Report of: Edward Highfield

Report to: Councillor Jack Scott (Cabinet Member for Transport and Development)

Date of Decision: 11 January 2019

Subject: Sheffield Inner Ring Road and Junctions – Scheme Consultation and Officer Recommendations

APPENDIX 'A' Preferred Preliminary Design

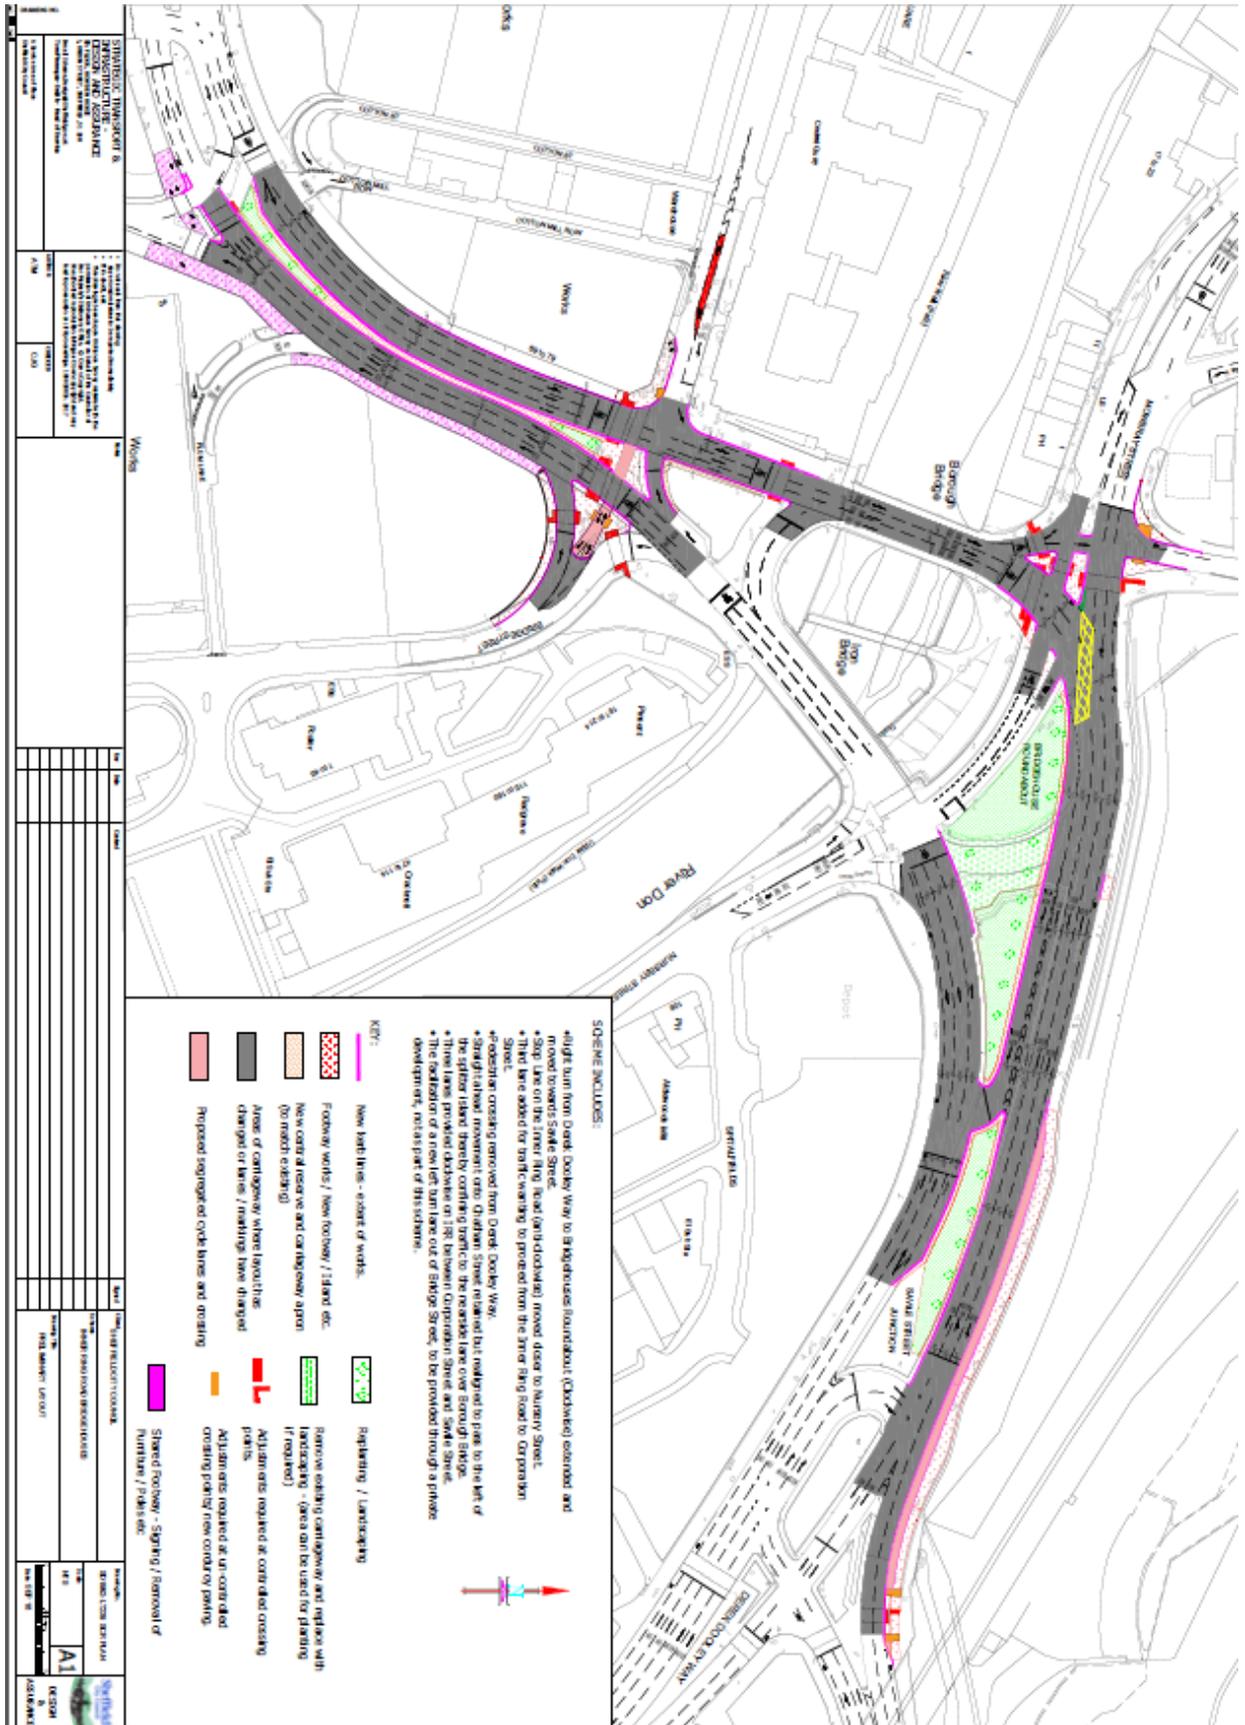
This is described as “to be promoted as one of the main routes into and out of the city centre”. The plan does not give the impression of a main route. It involves awkward and dangerous road crossings at both ends, Alma Street and Bridge Street, and is accessed across a shared-use footway.

This poorly designed crossing fails to meet the ‘need’ to ‘reduce journey times for all traffic modes’ and ‘provide better connectivity to and through the City Centre for all modes’.

The crossing could be improved by removing the general traffic turning off into Bridge Street. This would remove the need for a pedestrian crossing on Bridge Street and allow people using the cycle crossing to enter Bridge Street safely.

SCC response – see plan in Appendix E for more detail on cycle provision within the scheme. Your comments are however useful and will inform the design process.
